EMDF Comments Primarily Related to the Site Groundwater Characterization Fact Sheet
Due DOE June 7, 2022

Subject: Comments primarily related to the Site Groundwater Characterization fact sheet

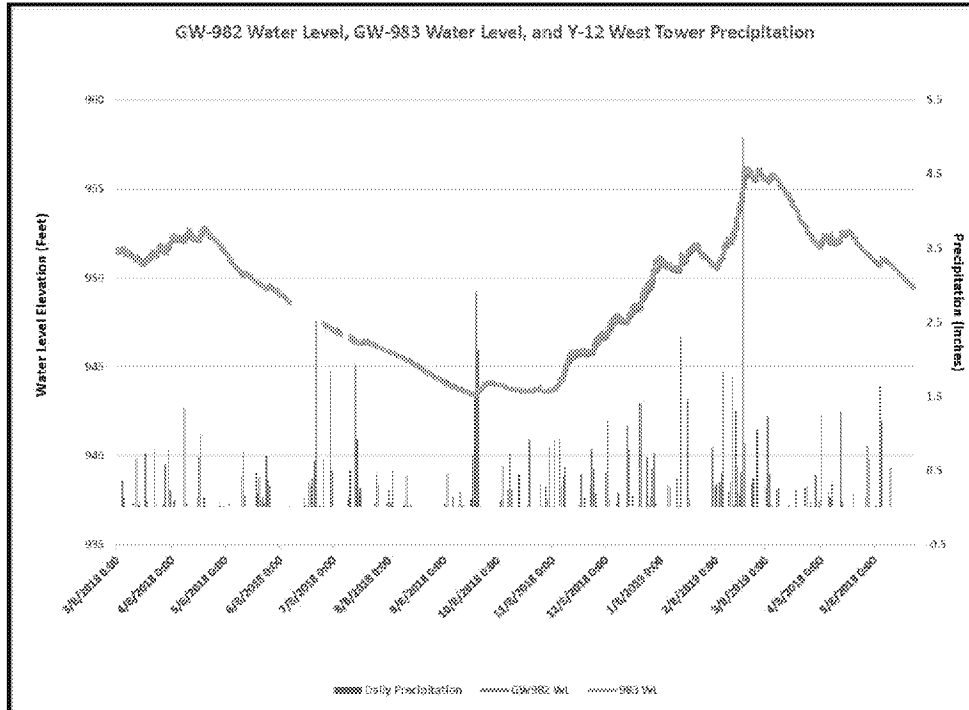
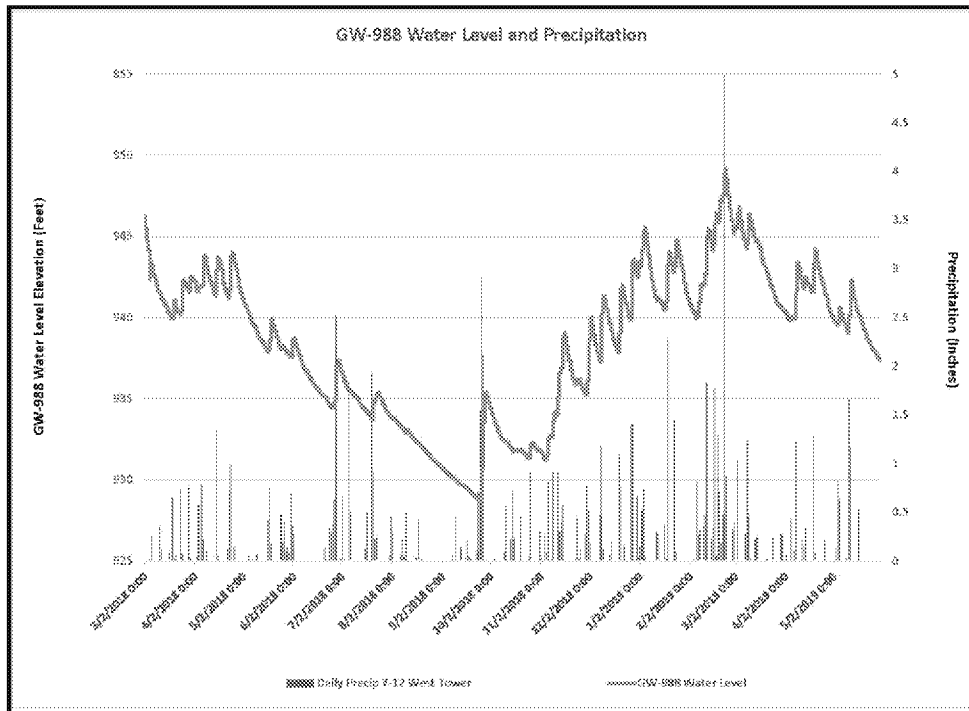
- 7) The Site Groundwater Characterization fact sheet correctly noted the water level response to rainfall. However, rainfall response in GW-988 was quick and response in GW-982/GW-983 was delayed.
